ADDENDUM NO. 2

Life Sciences Collaboration
 1910 N. Antelope Valley
 Parkway
 Lincoln, Nebraska
 TCEP No.: 716-002-12
 Davis Design.: 12-0077
 BVH No.: L12018.unl
 November 27, 2013

Below Floor Plumbing Plan
- Area A

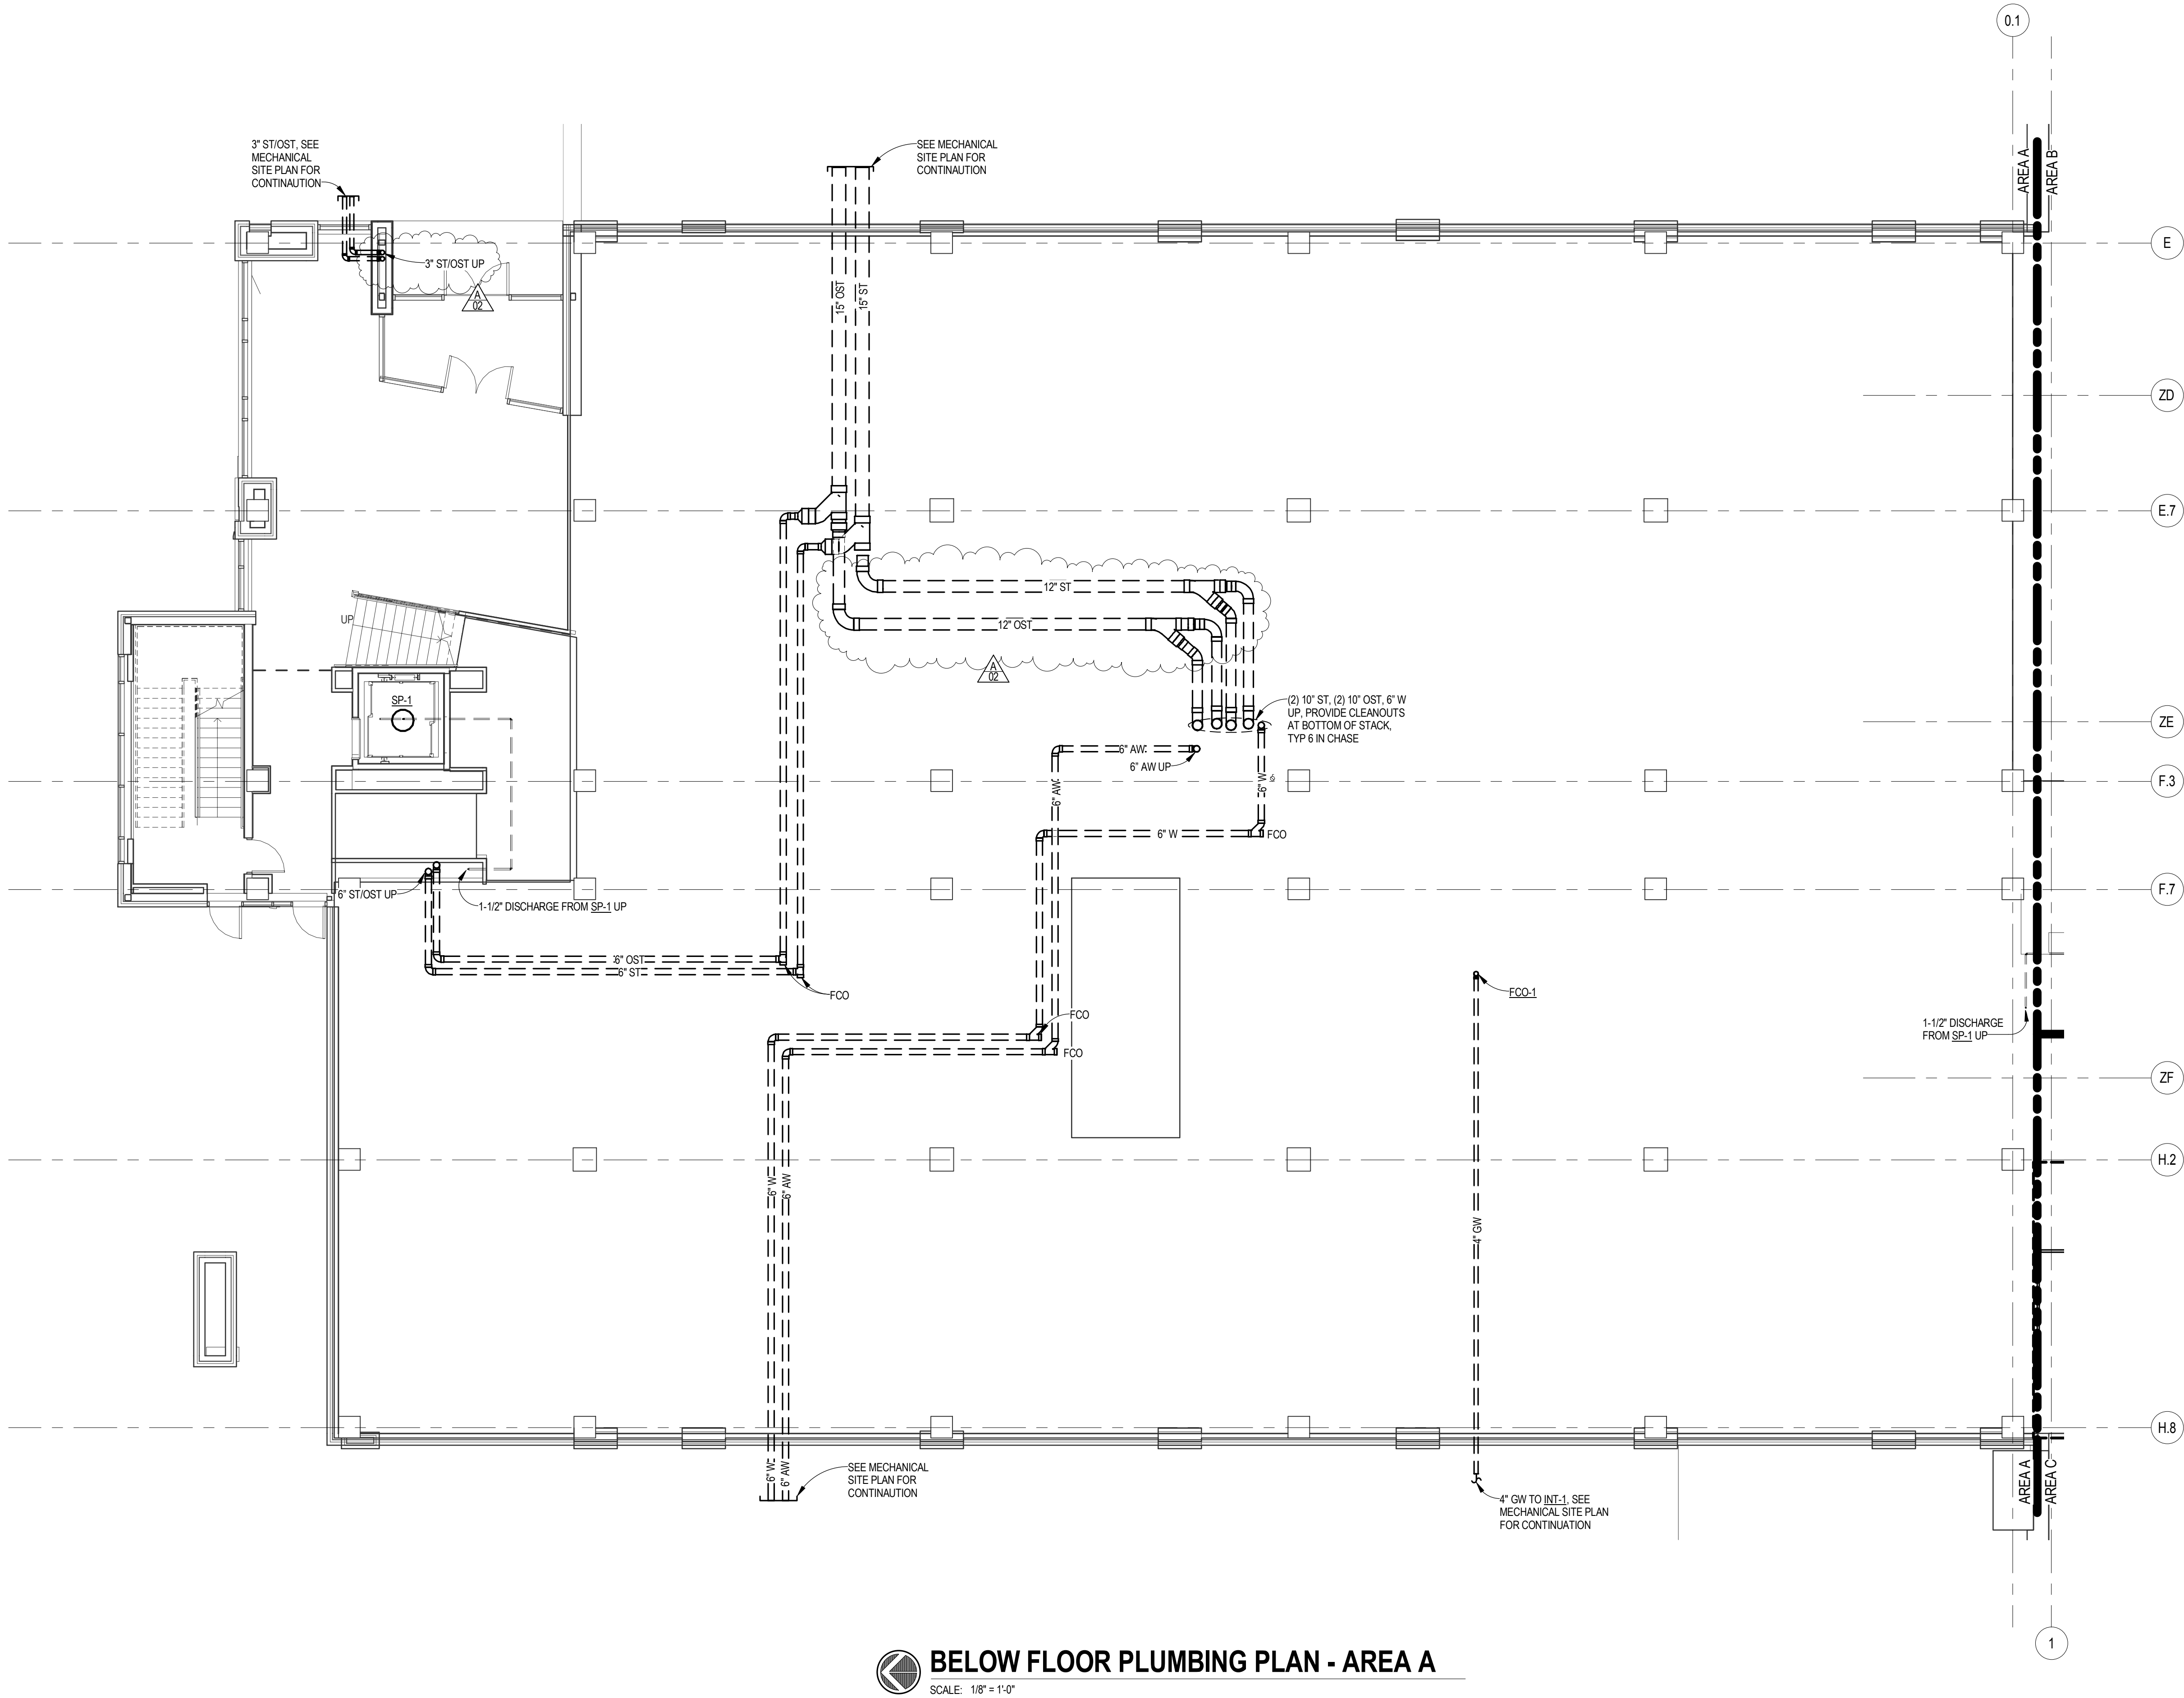
Item 2-58: P1.01 – Below Floor Plumbing Plan – Area A

See reissued sheet for revised storm piping sizing and routing.

First Floor Plumbing Plan -
Area D

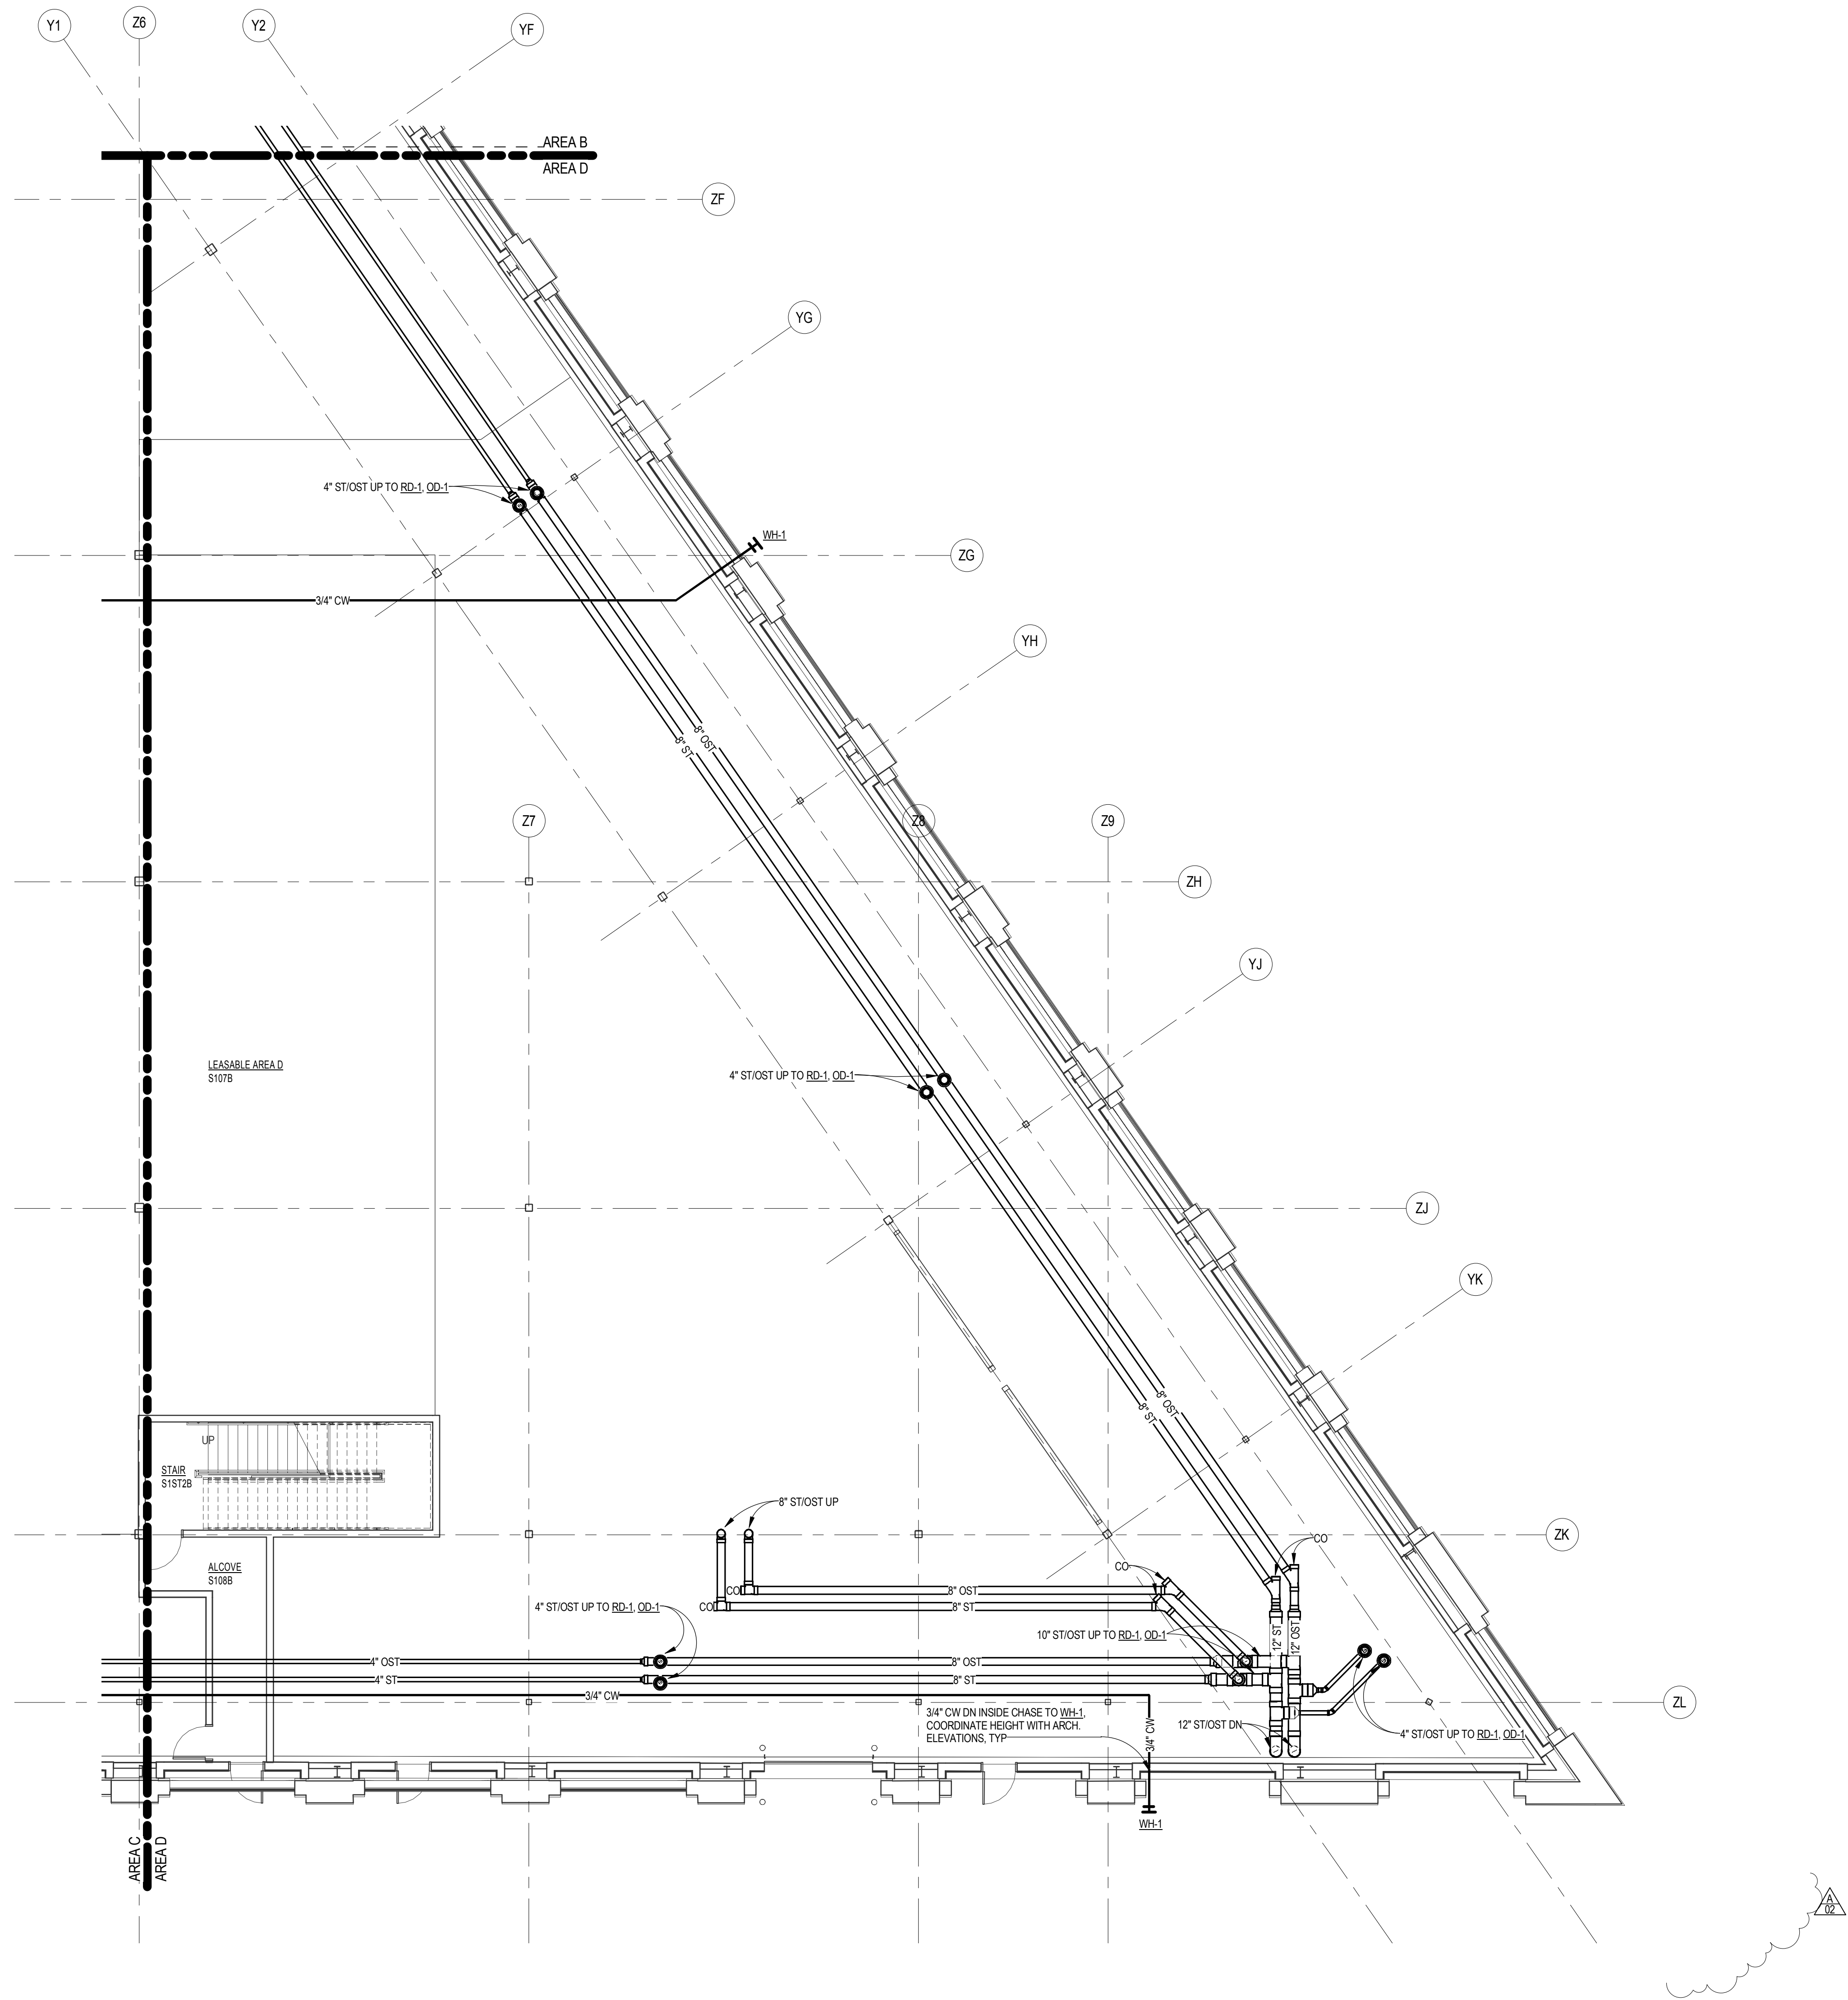
Item 2-61: P1.08 – First Floor Plumbing Plan – Area D

See reissued sheet for revised roof drain and storm piping sizing and routing.

Second Floor Plumbing
Plan - Area A

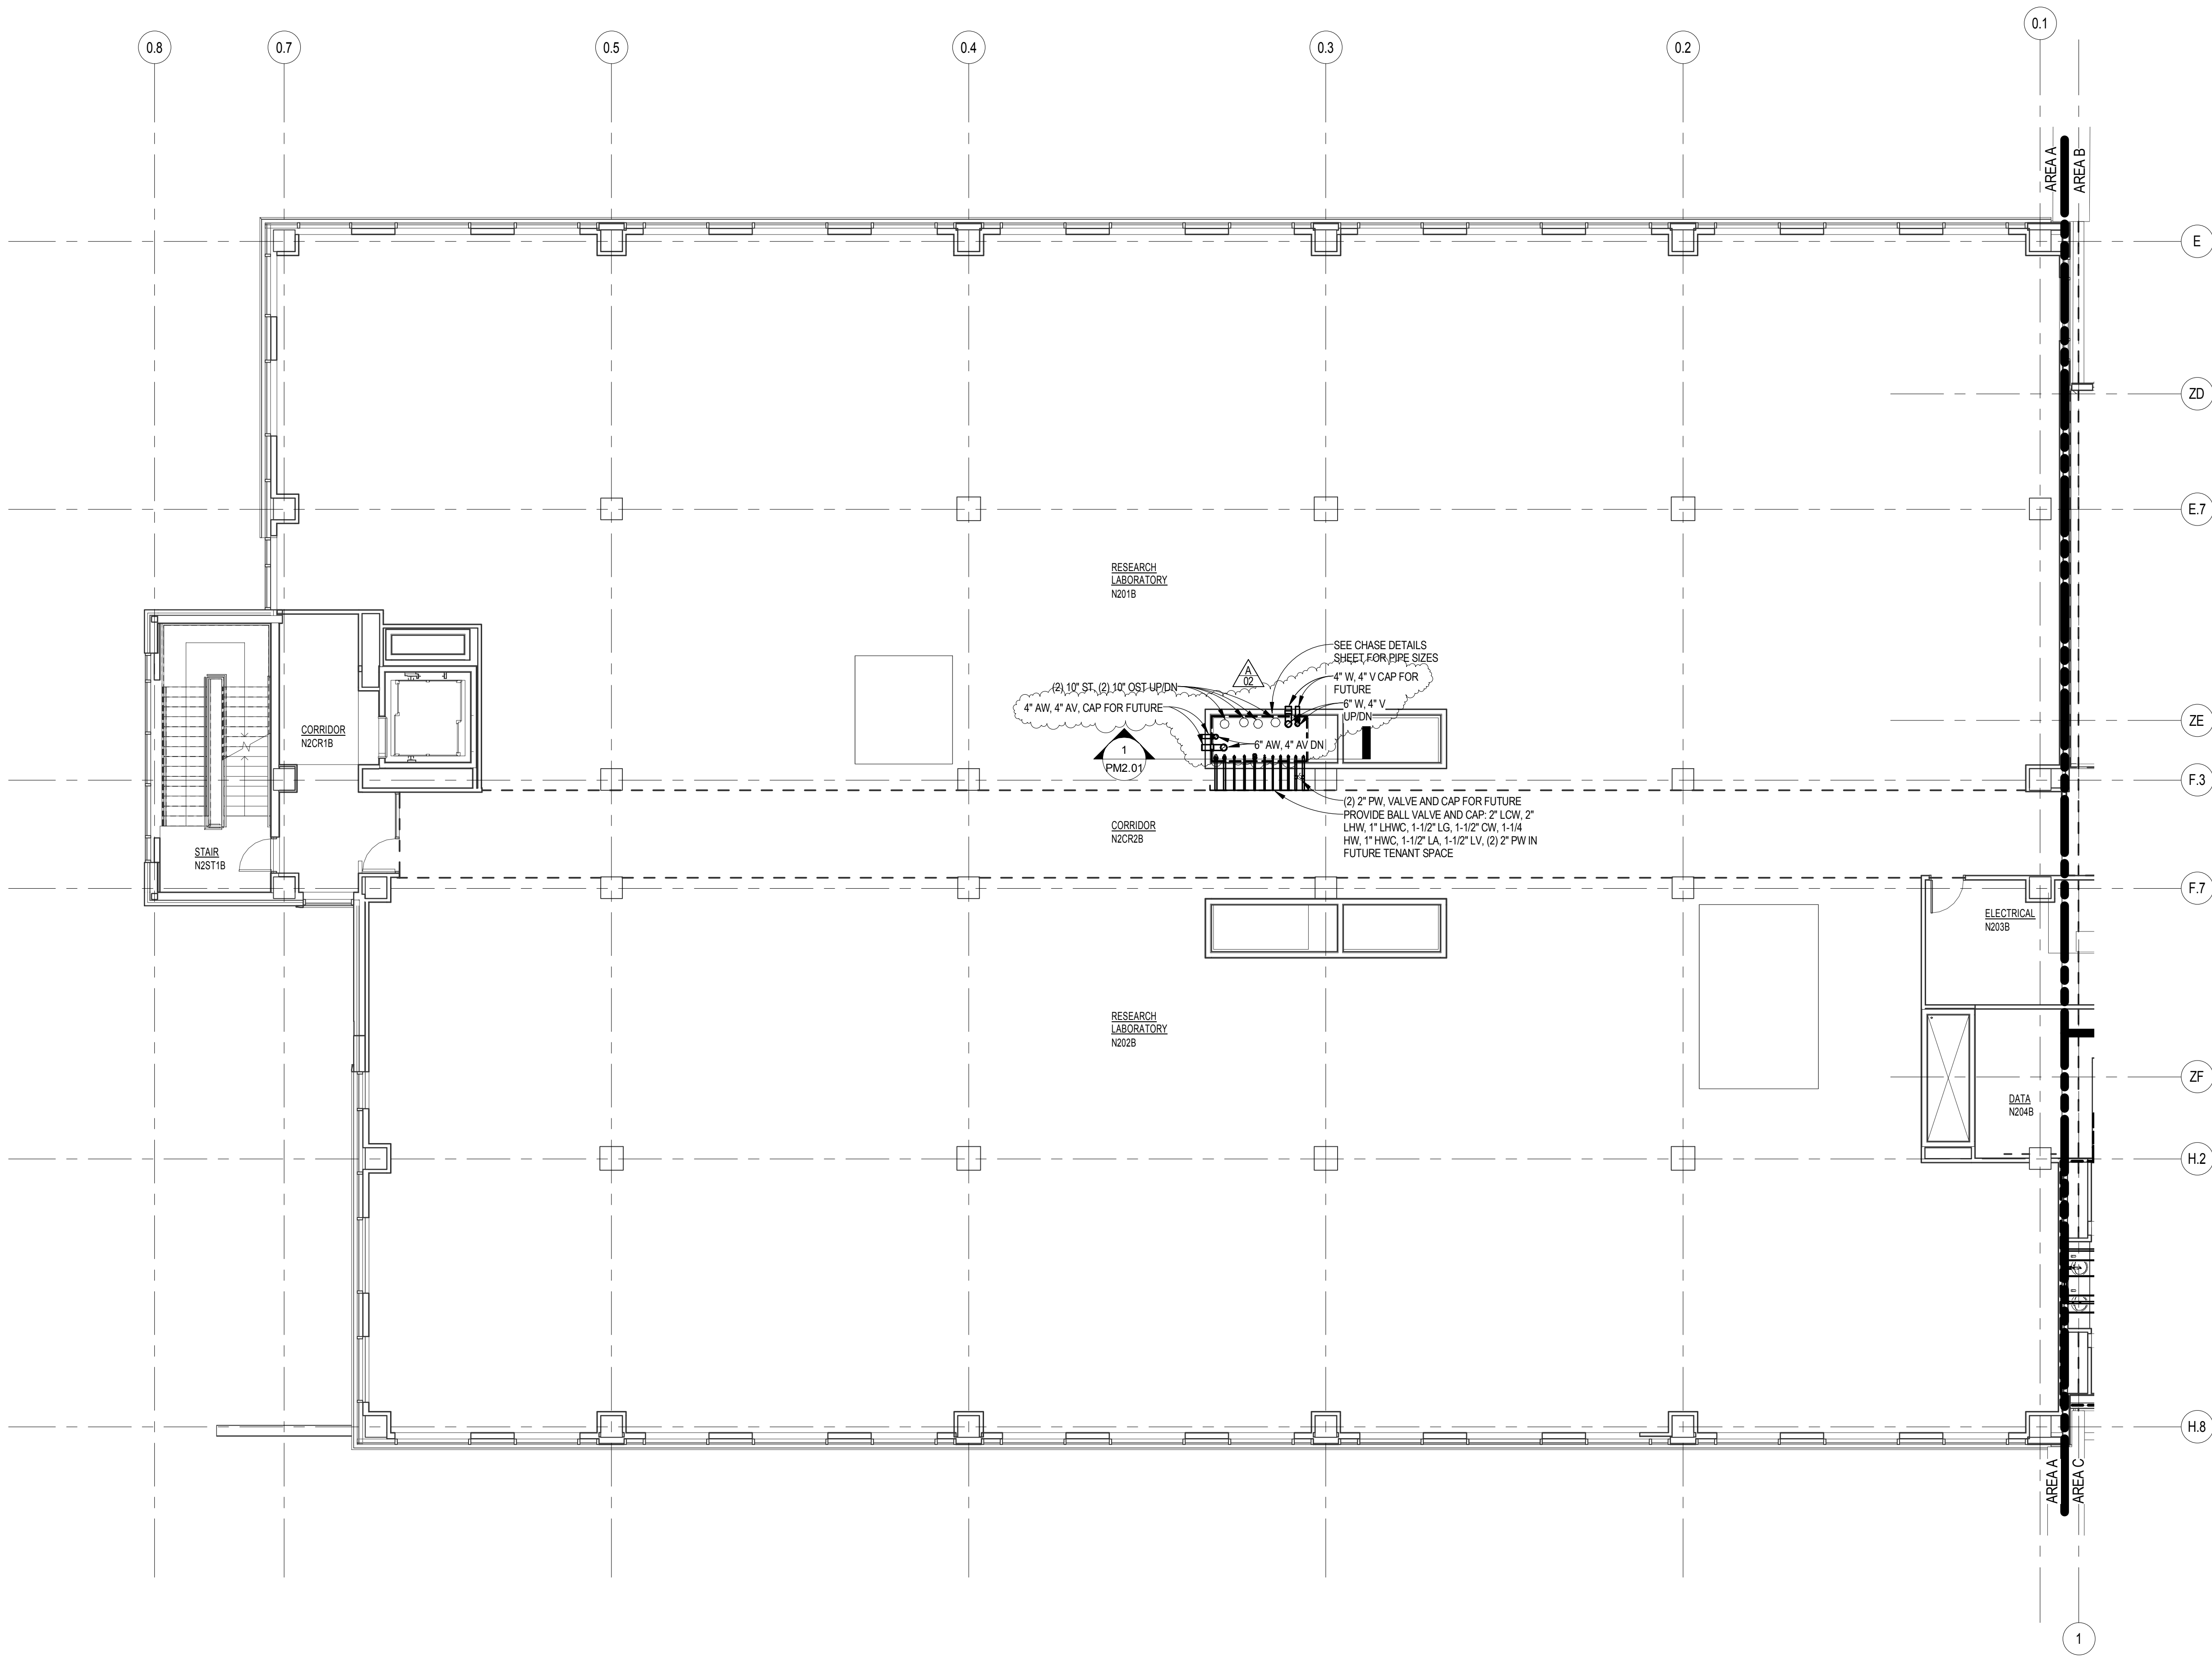
Item 2-62: P1.09 – Second Floor Plumbing Plan – Area A

See reissued sheet for added 4" V and 4" AV mains and stub-outs in the central plumbing chase.
